• • ADDENDUM # 2 ••

**PROJECT NUMBER: 130012-59
EASTERN REGIONAL WATER RECLAMATION FACILITY
OPERATIONS BUILDING RENOVATION
DUE DATE: 08/27/2025 @ 1:30 PM**

**EASTERN REGIONAL WATER RECLAMATION FACILITY
OPERATIONS BUILDING RENOVATION
PROJECT NO. 130012-59**

**CHANGES TO BID DOCUMENTS – SPECIFICATIONS AND CONTRACT
DOCUMENTS**

HVAC SECOND FLOOR DEMOLITION PLAN

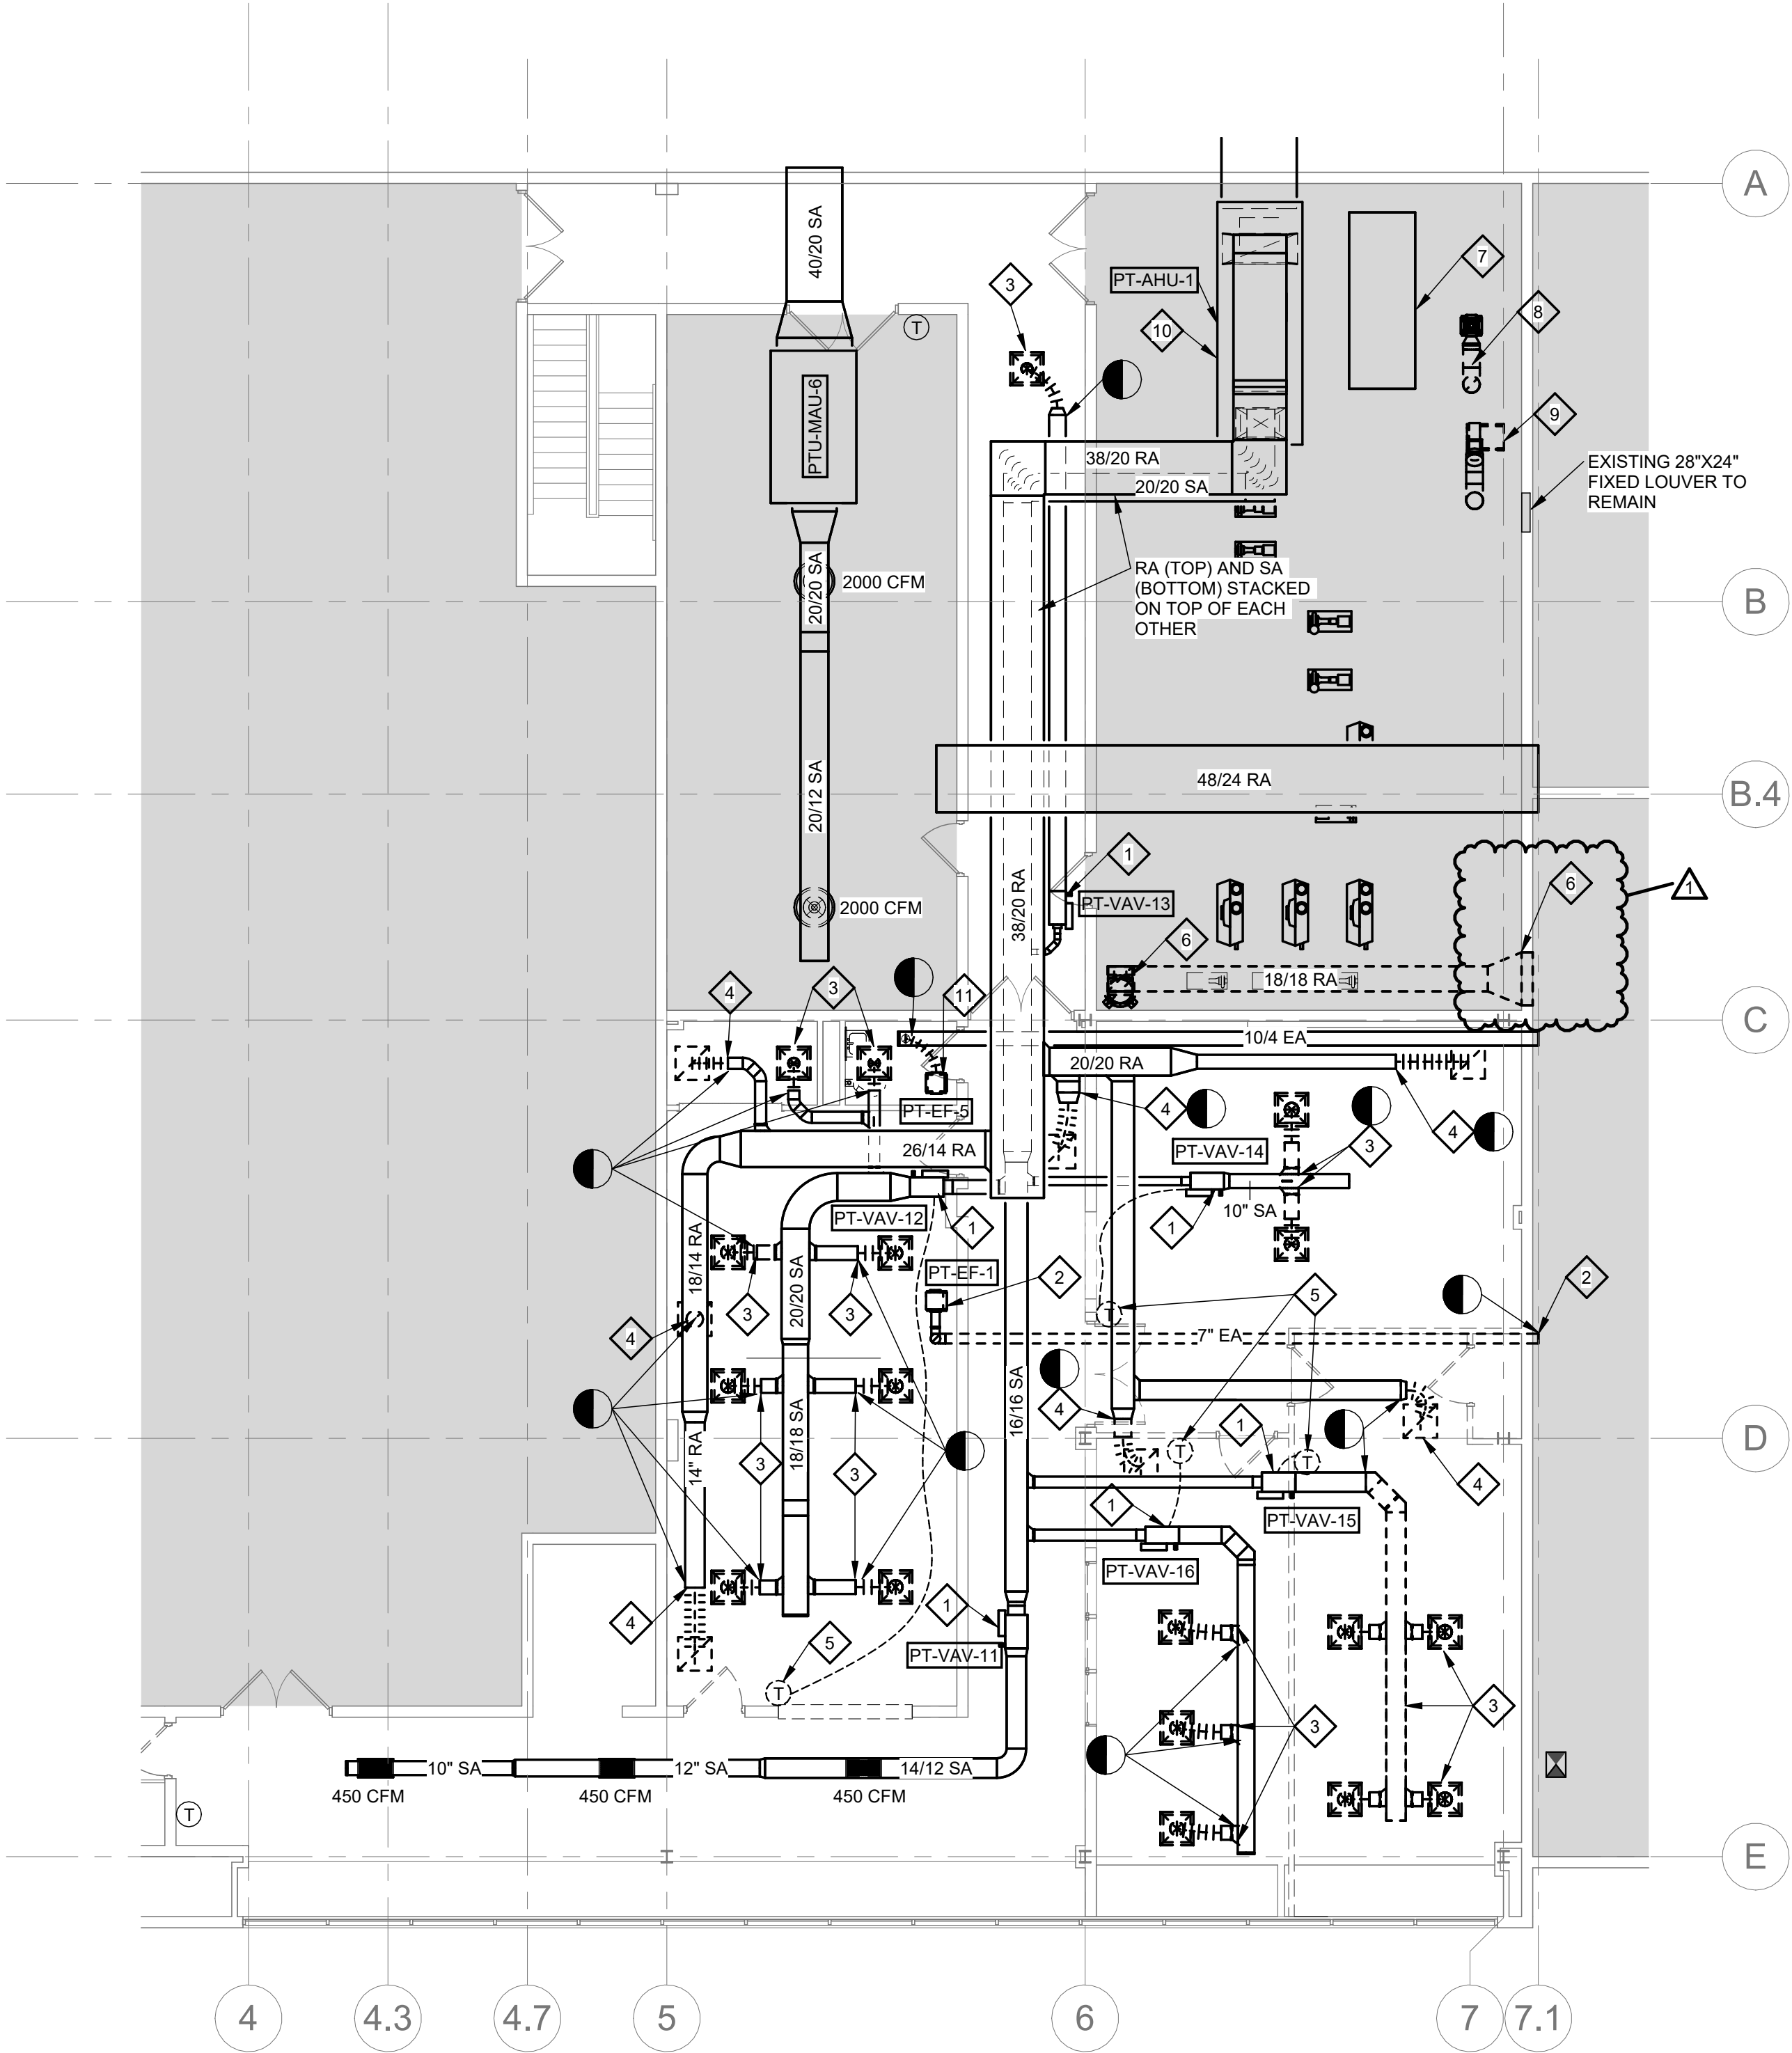
- a. Remove VAV box PT-VAV-8 to avoid new 1-hour fire partition in new work per attached sheet.
6. Sheet MD-102 HVAC SECOND FLOOR DEMOLITION PLAN
 - a. Revise Plan Note 6 per attached sheet.

- REMOVE AND RELOCATE EXISTING THERMOSTAT SERVING VAV BOX AND MAINTAIN CONTROL WIRE. EXTEND CONTROL WIRING TO NEW LOCATION SHOWN IN NEW WORK PLAN.
- REMOVE IN-LINE EXHAUST FAN PT-EF-4 SERVING LOCKER ROOMS BELOW AND ALL ASSOCIATED EQUIPMENT, DUCTWORK AND CONTROLS COMPLETE. REMOVE EXHAUST DUCTWORK AND EXTERIOR LOUVER COMPLETE. COORDINATE RATED WALL INFILL WITH ARCHITECTURAL DRAWINGS.

SECOND FLOOR PLAN
**Eastern Regional Water
Reclamation Facility Operations
Building Renovation**

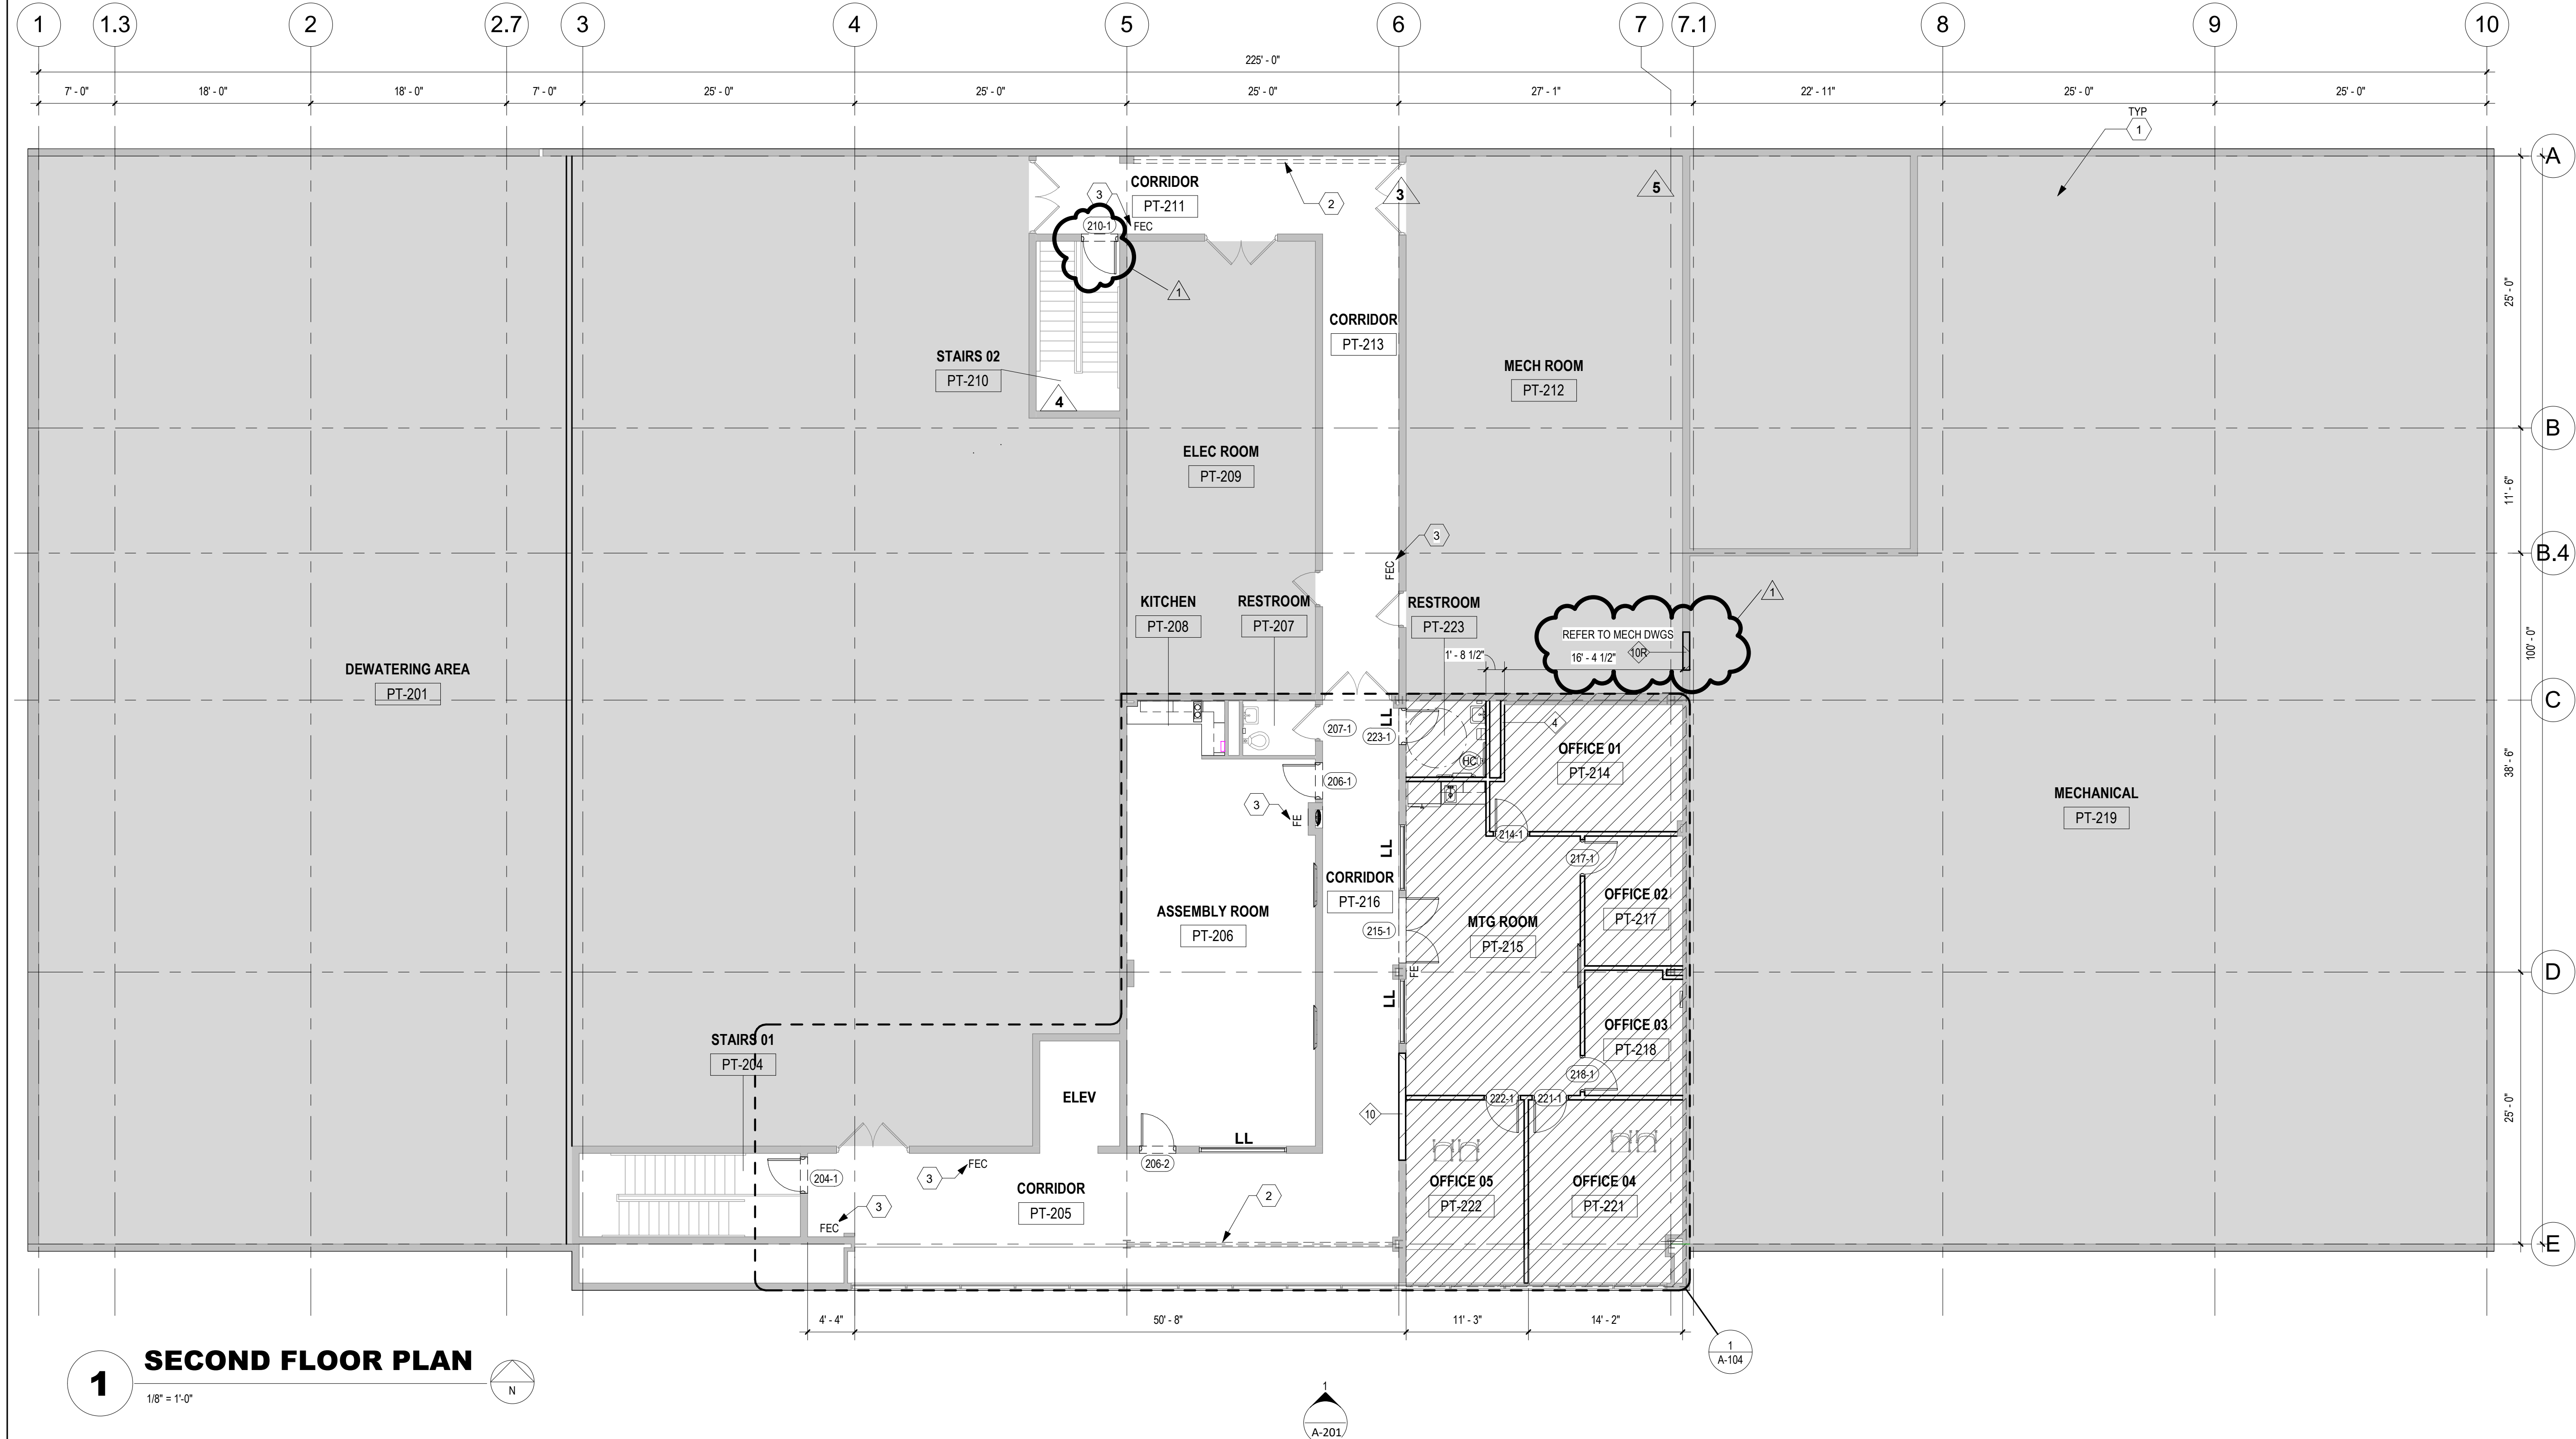
7. Sheet A-103 SECOND FLOOR PLAN
 - a. Add infill partition at rated wall location per attached sheet.
 - b. Add door 210-1 per attached sheet.
8. Sheet A-201 EXTERIOR BUILDING ELEVATIONS

EXTERIOR BUILDING ELEVATIONS

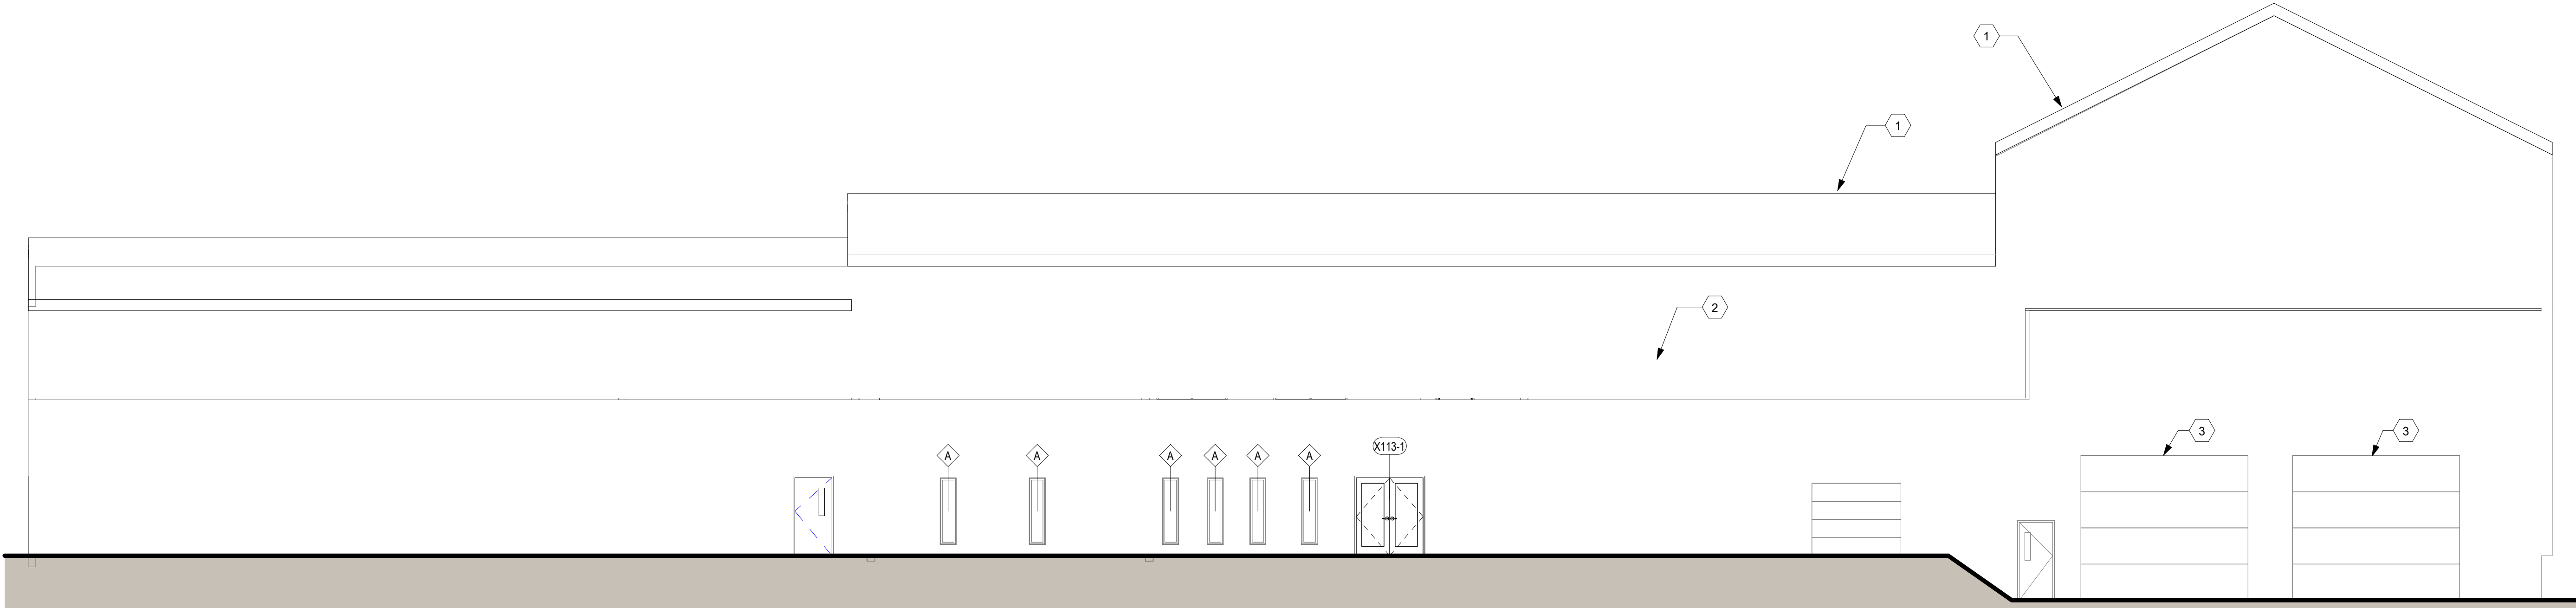
- a. Add CODED NOTE 9 per attached sheet.
9. Sheet A-420 VERTICAL CIRCULATION STAIR PLANS & SECTIONS
 - a. Add CODED NOTE 14 per attached sheet.
 - b. Add notes to section 4/A-420 per attached sheet.

| CODED NOTES | |
|-------------|--|
| 9 | PROVIDE REPLACEMENT ELEVATOR CEILING & LED LIGHTS BY APPROVED ELEVATOR CONTRACTOR. CONTACT OWNER'S SERVICE CONTRACT REPRESENTATIVE FROM OTIS FOR CEILING UPGRADE. |
